Appln. No.: 10/535,569 Amendment Dated: June 15, 2007 MAT-8672US

Reply to Office Action of: March 22, 2007

Remarks/Arguments:

EXHIBIT1

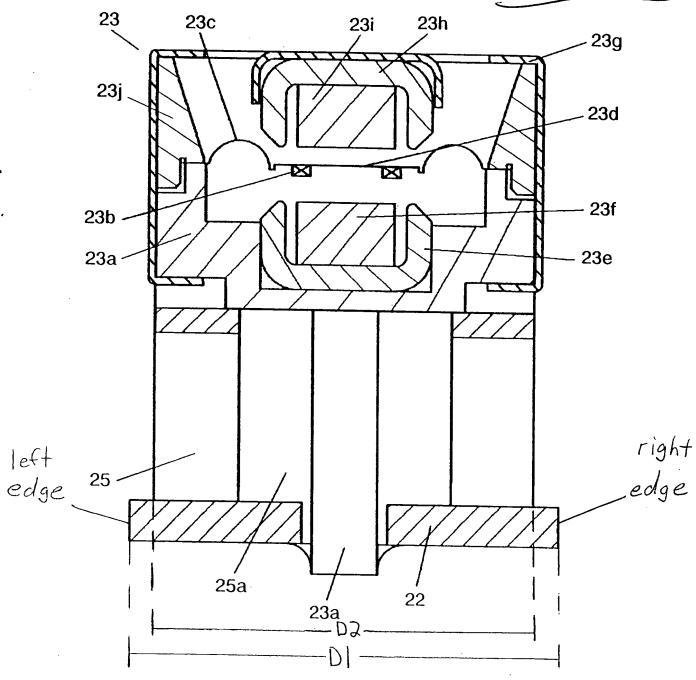
Basis for these amendments may be found in Figs. 1 and 2. With regard to claim 1, Mullenborn et al. does not disclose "...each of said loudspeakers covers most of a distance extending from edge to edge of said printed circuit board."

Applicants have enclosed a copy of Applicants' Fig. 2 with markings (Exhibit 1) and a copy of Fig. 1c of Mullenborn et al. (Exhibit 2) to help in explaining the above features. Exhibit 1 corresponds to an exemplary embodiment of the present invention. Exhibits 1 and 2 are being submitted for illustrative purposes only.

In contrast, the exemplary embodiment of Applicants' invention includes a plurality of speakers 23, "...wherein each of said loudspeakers covers most of a distance extending from edge to edge of said printed circuit board." Fig. 1 shows a plurality of speakers 23 mounted on printed circuit board 22. As shown at Exhibit 2, the printed circuit board 22 includes a left edge and a right edge. Each of said speakers 23 covers a distance (D2) that is **most of a distance** (D1) extending from edge to edge (left edge to right edge). This gives Applicants' invention an advantage because a plurality of speakers can be easily manufactured and assembled in a thin and compact manner.
